November 21, 2017

**Re: 40B - Peer Review  
Cascade Wayland  
113-119 Boston Post Road  
Wayland, Massachusetts**

SHEET NAME:  
GRADING, DRAINAGE, AND  
UTILITY PLAN

SHEET #  
C301

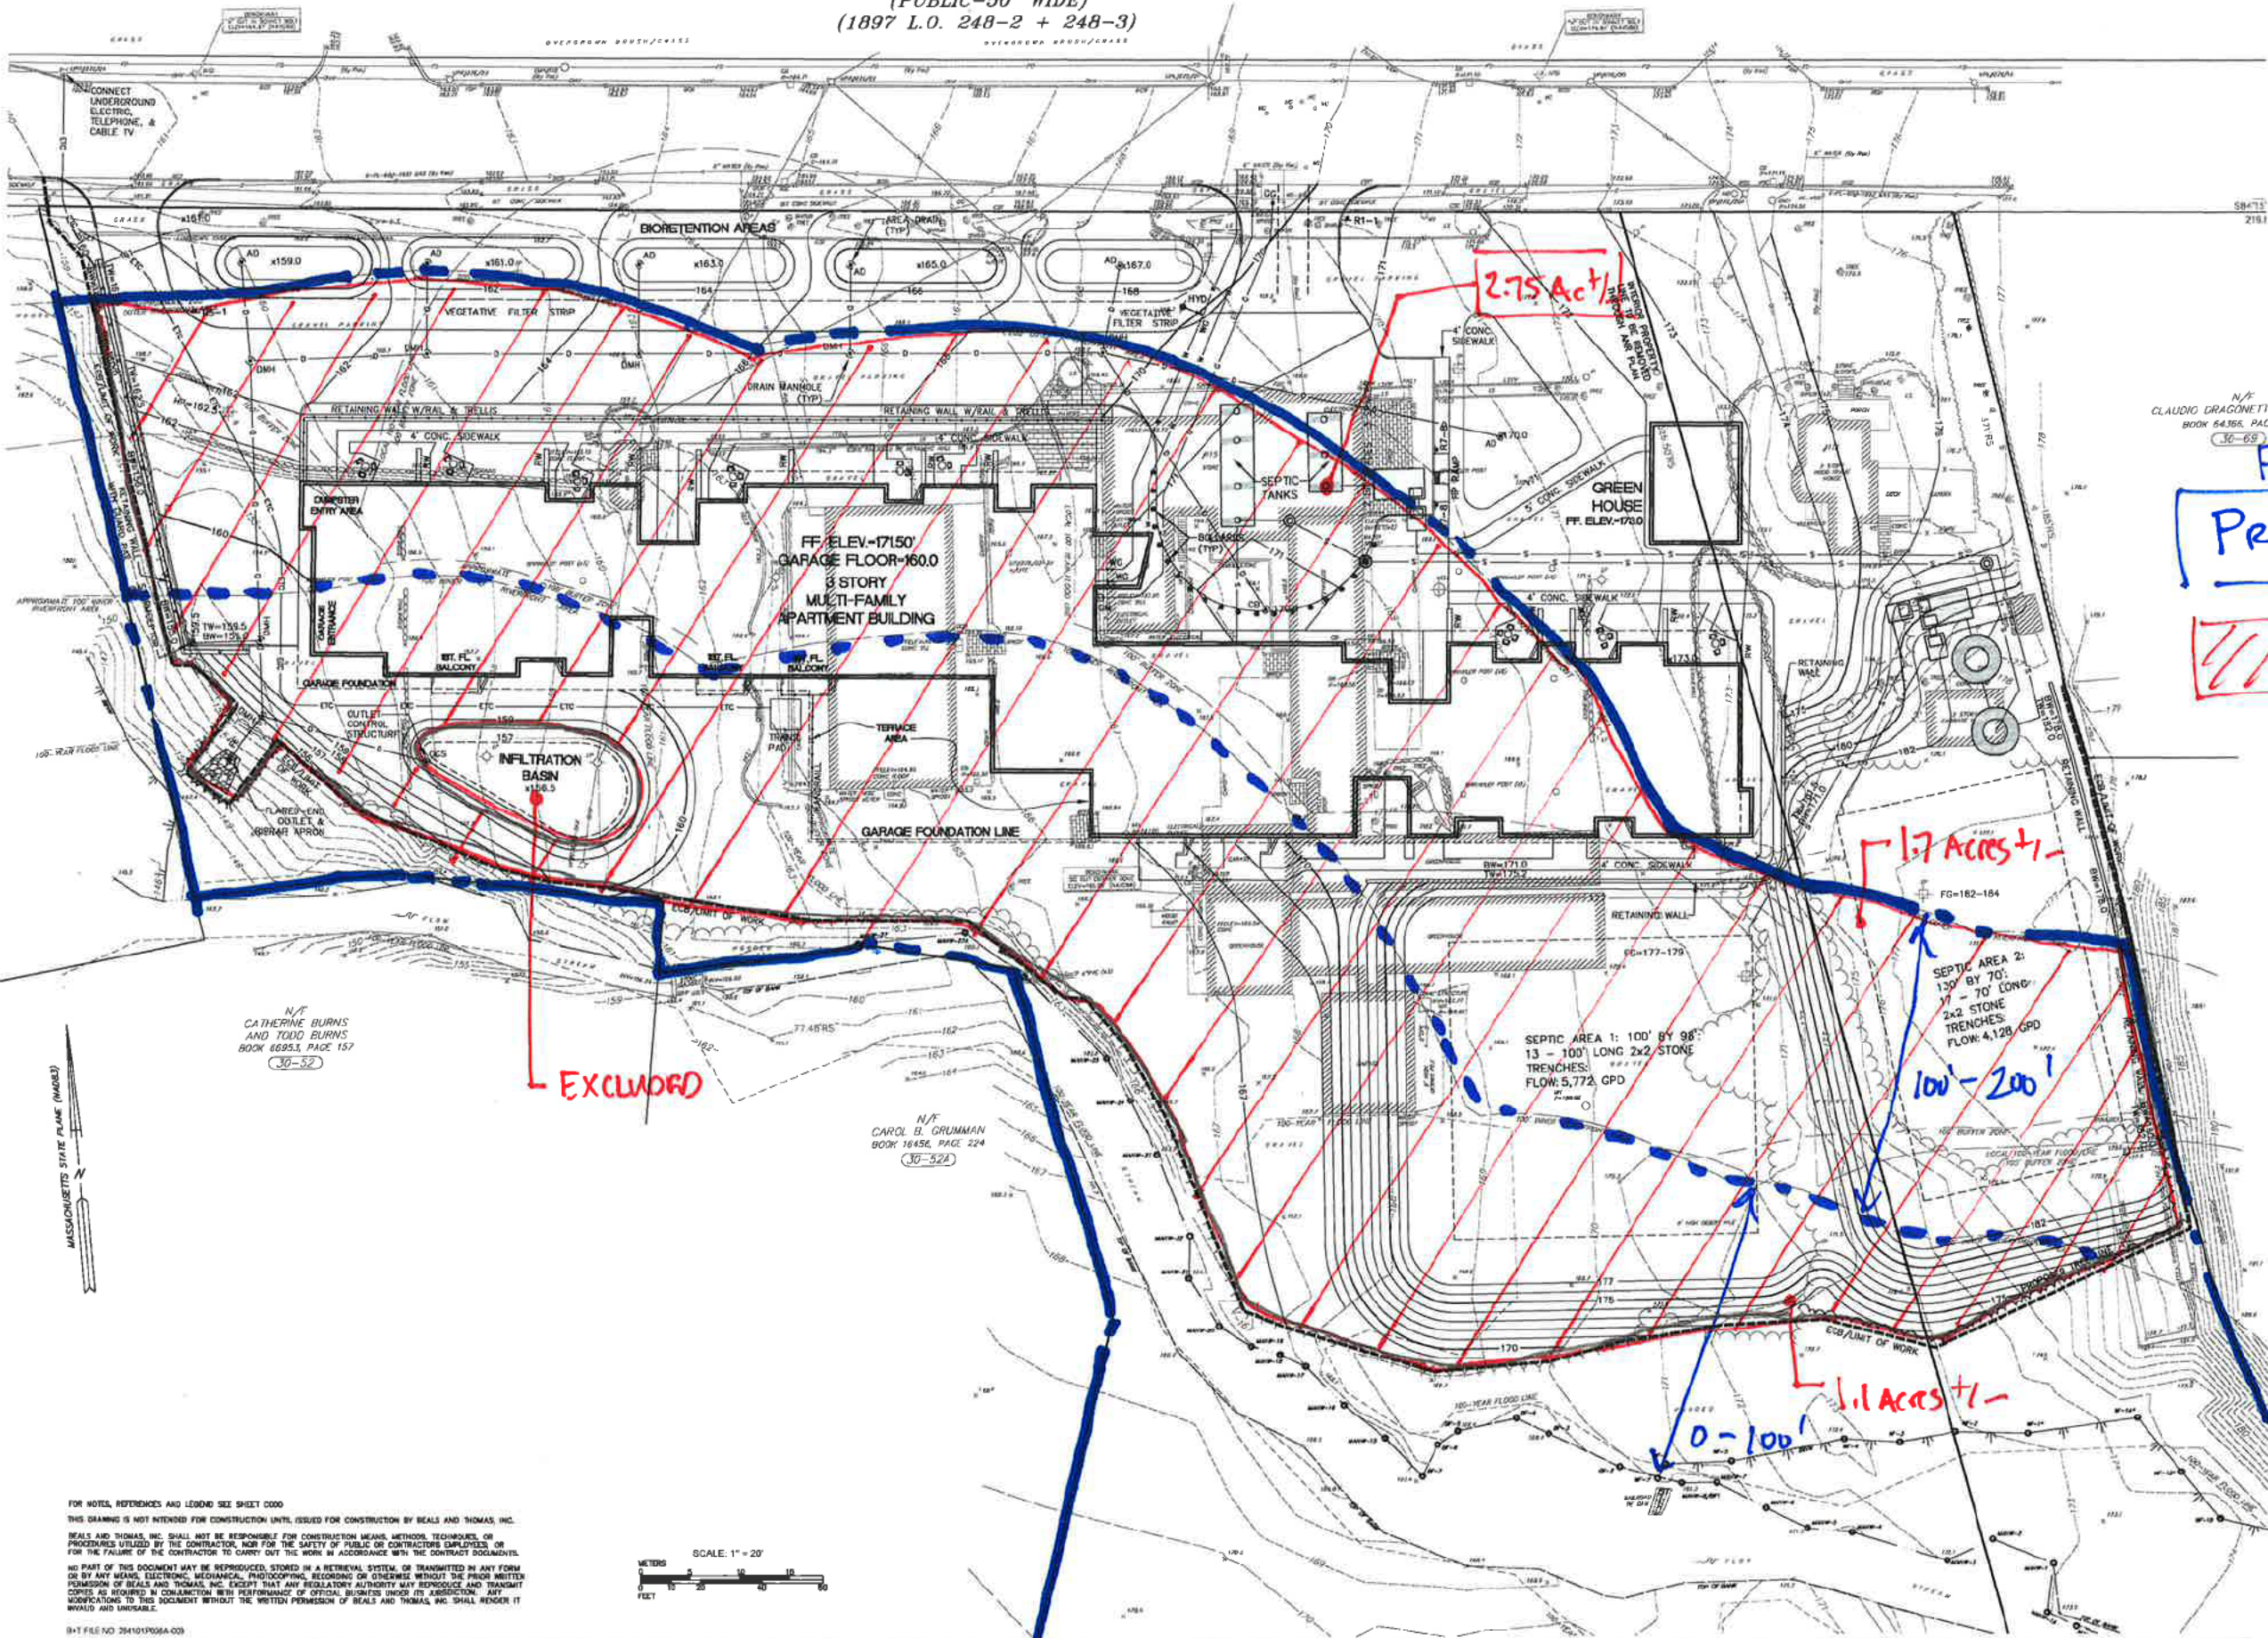
- The plans indicate a large installation of tanks and related structures adjacent to Septic Area 2 but no access is provided for maintenance or other periodic operational needs.

- The plans include a retaining wall approximately 10 feet from the limit of Septic Area 2. Applicable regulations require a 15 foot setback to downhill slopes which is not met. It is also unclear how runoff patterns will be maintained so that runoff originating on the adjacent property does not accumulate along the face of wall.

12. Grading required to accommodate the proposed septic system and infiltration basin preclude emergency vehicle access to the rear of the building. Given the building's proposed height (40') and length (485') the lack of access for emergency responders may present an unsafe condition. Grading and access should be coordinated with the Wayland Fire and Police Departments to ensure suitable access. According to Massachusetts Fire Protection Regulations, for buildings with fully automatic sprinkler systems, the maximum allowable distance from an approved emergency access road to any portion of the building/wall is 250 feet. Based on our review of the proposed plans the required dimension is not met and approximately 225 feet of the building does not meet the standard. See
